**Request for Information – Local Government Official Information and Meetings Act 1987**

1. Copies of all briefings, memos and aide memoires relevant to the decisions around the tobys, toby covers, and water backflow preventers installed as part of the Queen St upgrade in Wainuiomata.
2. All internal emails by Hutt City Council staff relating to the tobys, toby covers and water backflow preventers.
3. Copies of any correspondence between Hutt City Council and Wellington Water, or Queen St upgrade contractors about the tobys, toby covers, and water backflow preventers.

**From:** [REDACTED]  
**Sent:** Wednesday, September 7, 2022 12:04 PM  
**To:** [REDACTED]@jfcltd.co.nz; [REDACTED]@wellingtonwater.co.nz);  
[REDACTED]@huttcity.govt.nz;  
**Cc:** [REDACTED]@huttcity.govt.nz; [REDACTED]@wellingtonwater.co.nz); [REDACTED]@huttcity.govt.nz; [REDACTED];  
[REDACTED]@ccl.co.nz; [REDACTED]@huttcity.govt.nz  
**Subject:** MOM 07/09/22 - Queen Street watermain renewal - Weekly catch-up

DETAIL FOR COMMERCIAL INGROUND CONNECTION (MEDIUM HAZARD DOUBLE CHECK VALVE)  
N.T.S.

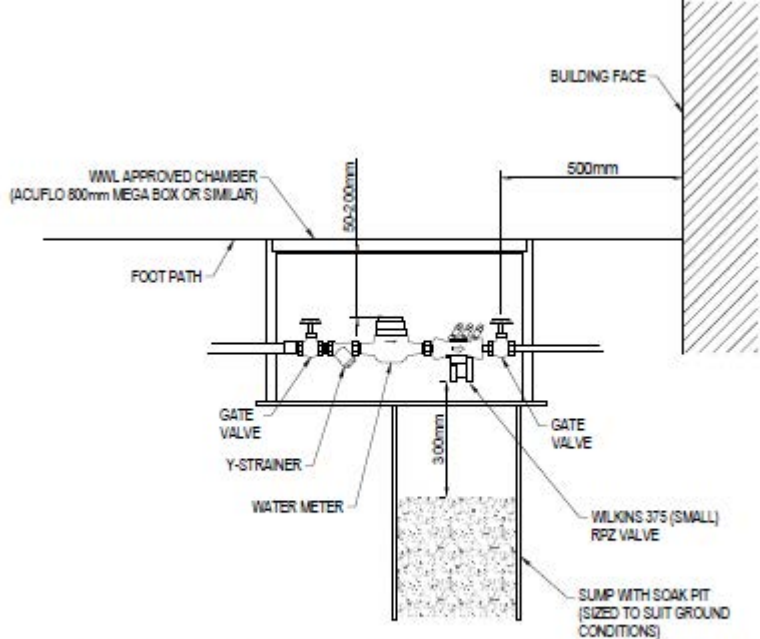
Page 175 & 176 shows the typical domestic and buried commercial connections, from the WWL GIS all of those connections appear to be 25mm PE100 SDR11 PIPE. This pipe would need to be buried 0.75m below the footpath and then will come up to the toby as shown in the detail.

DETAIL FOR COMMERCIAL INGROUND CONNECTION (MEDIUM HAZARD DOUBLE CHECK VALVE)  
N.T.S.

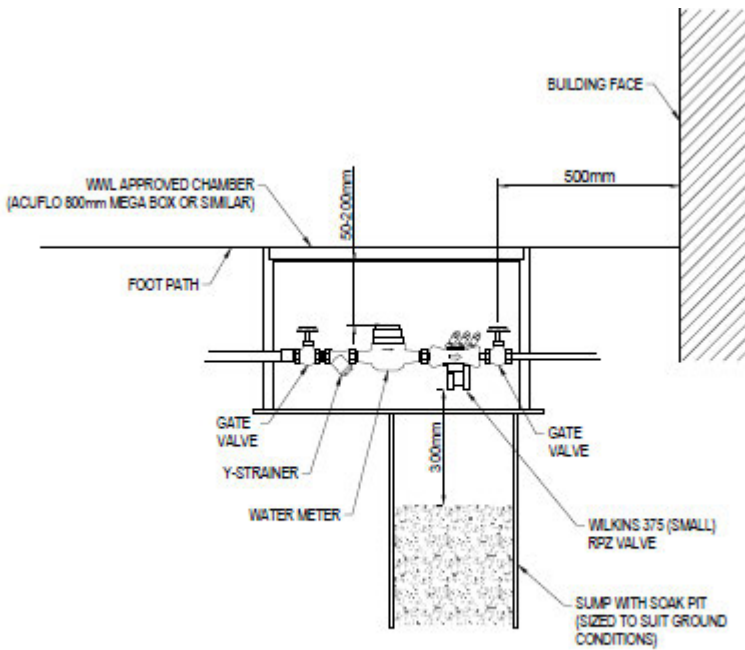
Is there some guidance as to what counts as medium or high hazard, I have also not found any guidance in the 2021 spec and the standard detail only refers to one layout (WWL Drawing WS09). What was used to determine the requirements for the two details below.

Typically, all non-domestic connections should be fitted with an approved backflow prevention device appropriate to the level of risk associated with the activity within the property. On that understanding all water connections in Queen Street should have an (appropriate) approved backflow prevention device installed.

Where non-domestic connections that are not designated as a medium or high risk, a non-testable double check valve installed on the connection can be achieved with a manifold toby valve with internal double check valve or an inline (non-testable) double check valve.

Yes, Wellington Water would like these installed outside all properties. This will cover a possible change in risk, if a property changes from low risk to medium/high risk in the future.

DETAIL FOR COMMERCIAL INGROUND CONNECTION (MEDIUM HAZARD DOUBLE CHECK VALVE)  
N.T.S.

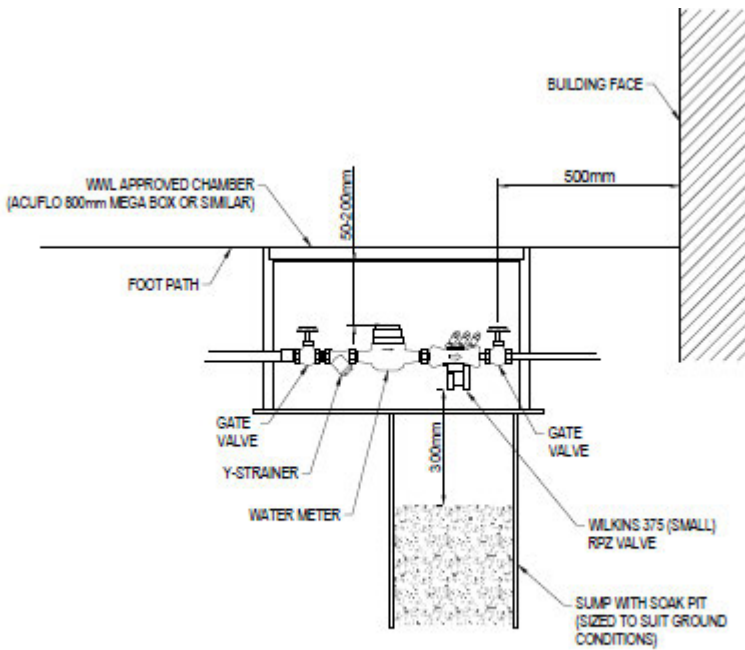
Is there some guidance as to what counts as medium or high hazard, I have also not found any guidance in the 2021 spec and the standard detail only refers to one layout (WWL Drawing WS09). What was used to determine the requirements for the two details below.

Typically, all non-domestic connections should be fitted with an approved backflow prevention device appropriate to the level of risk associated with the activity within the property. On that understanding all water connections in Queen Street should have an (appropriate) approved backflow prevention device installed.

Where non-domestic connections that are not designated as a medium or high risk, a non-testable double check valve installed on the connection can be achieved with a manifold toby valve with internal double check valve or an inline (non-testable) double check valve.

Yes, Wellington Water would like these installed outside all properties. This will cover a possible change in risk, if a property changes from low risk to medium/high risk in the future.

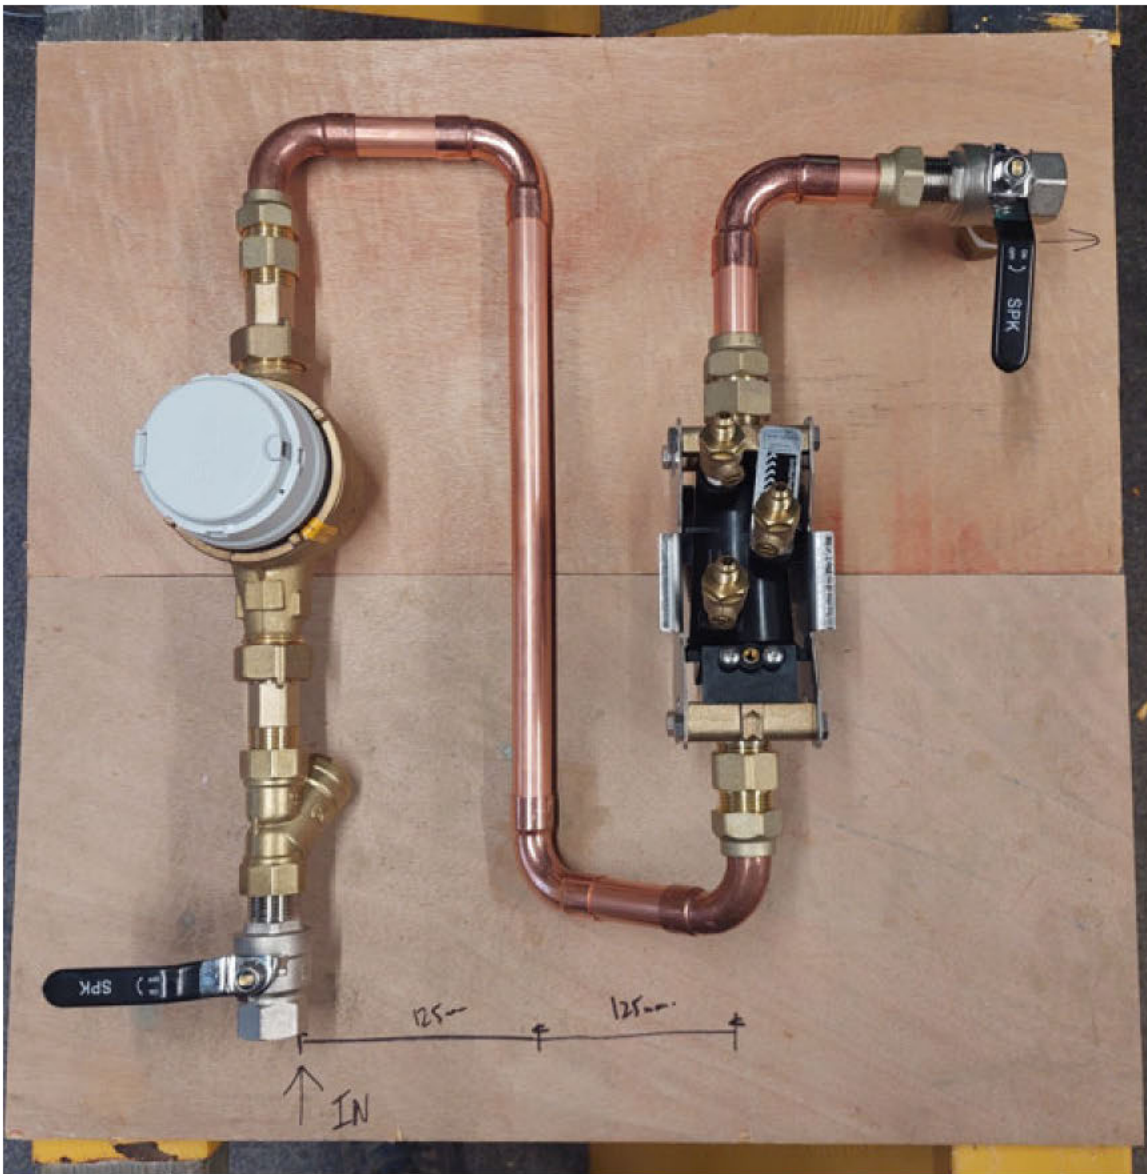
I can get small concrete chambers as below to install the valves, strainer, meter and backflow within them, if I have my measurements correct the square infill lids should fit straight on top of them. We will have to have holes drilled for the inlets, outlets and drain. We may also need to make up some brackets to take the weight of all the fittings.

One of my guys has mocked up the arrangement to ensure it all fits within the chamber size (plywood cut to size).

But they will be very difficult to open in a hurry, once in place with the paving stones. There are no lifting eyes in the frame. They have set screws, which you remove, then screw in a lifting eye. So cant see how a property owner, even with 2 people, will get it up to turn of toby if they have a leak. I suspect most plumbers will struggle to get them up?
